## ROCKAWAY BEACH STABILIZATION PROJECT

### Addendum No. 2 July 24, 2013

Drawing No. **TC-01**

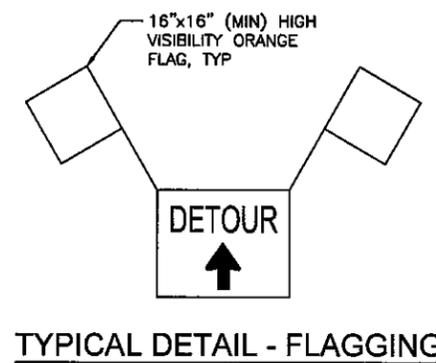
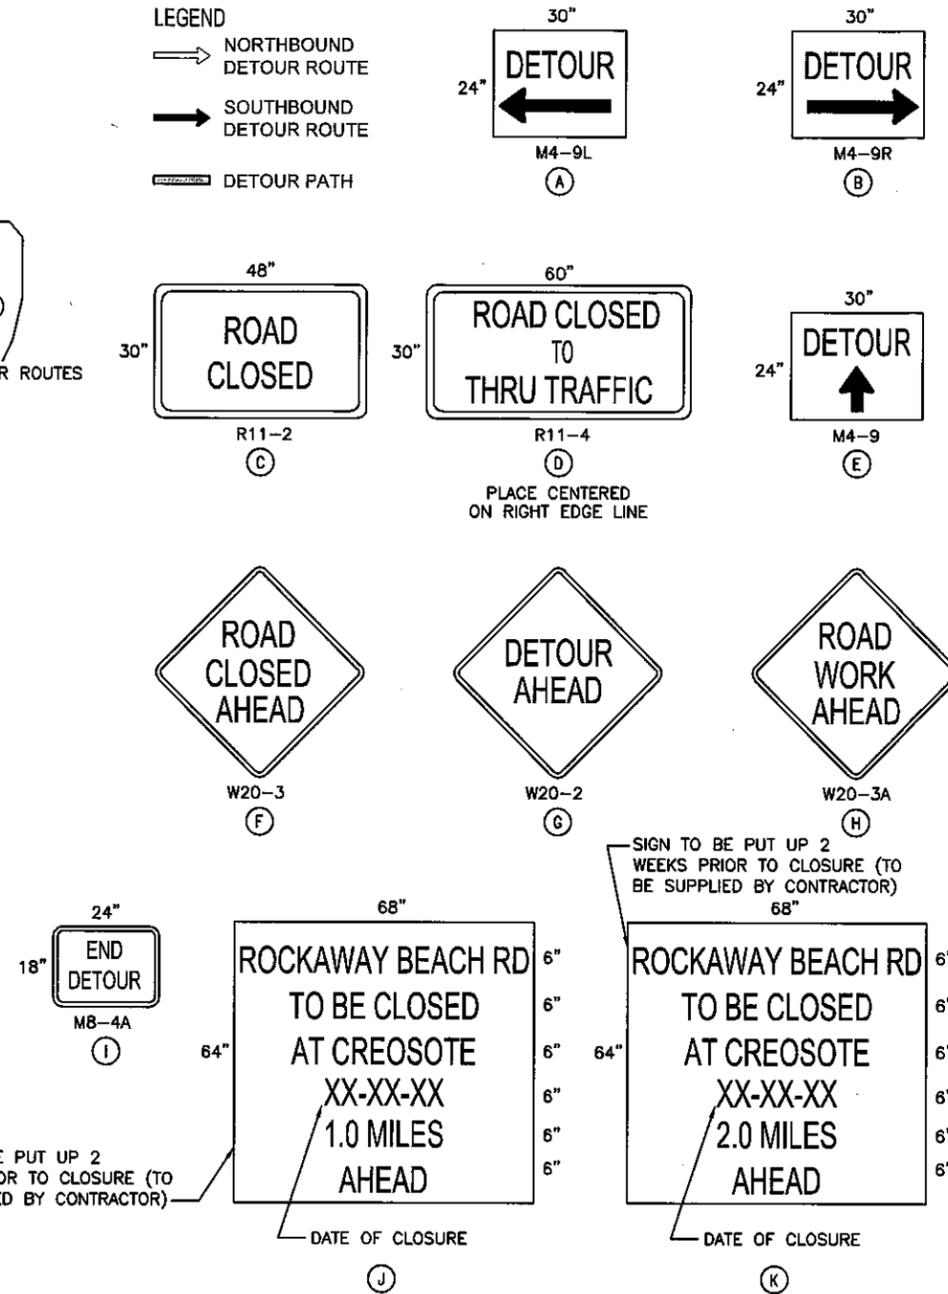
2.002	GW-02	Remove sheet GW-02 and replace with the attached sheet GW-02.
2.003	TC-01	Remove sheet TC-01 and replace with the attached sheet TC-01.
